APPLICATION NO.	FILING DATE	FIRST NAMED INVENTOR	ATTORNEY DOCKET NO.	CONFIRMATION NO.
10/586,956	07/25/2006	Tomoharu Horio	10921.421USWO	3401
52835 7590 03/09/2009 HAMRE, SCHUMANN, MUELLER & LARSON, P.C. P.O. BOX 2902			EXAMINER	
			LIU, LI	
MINNEAPOLIS, MN 55402-0902			ART UNIT	PAPER NUMBER
			2613	
			MAIL DATE	DELIVERY MODE
			03/09/2009	PAPER

DETAILED ACTION

Figure O1

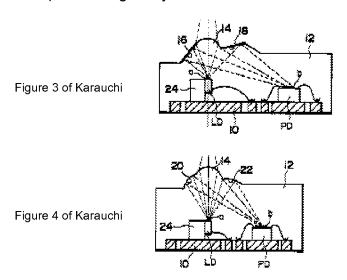
By using the light receiving element of Karauchi to detect the incoming signals, instead of monitoring, as taught by Maeno, a bidirectional communication can be formed. Therefore, it would have been obvious to one of ordinary skill in the art at the time the invention was made to use the photodetector to receive the incoming signal as taught by Maeno in the system of Maeno and the inclined surface to refract the incoming light to the photodetector (as shown in the following Figure O1), and then a compact bidirectional optical transmission module (Figure O1) can be obtained.
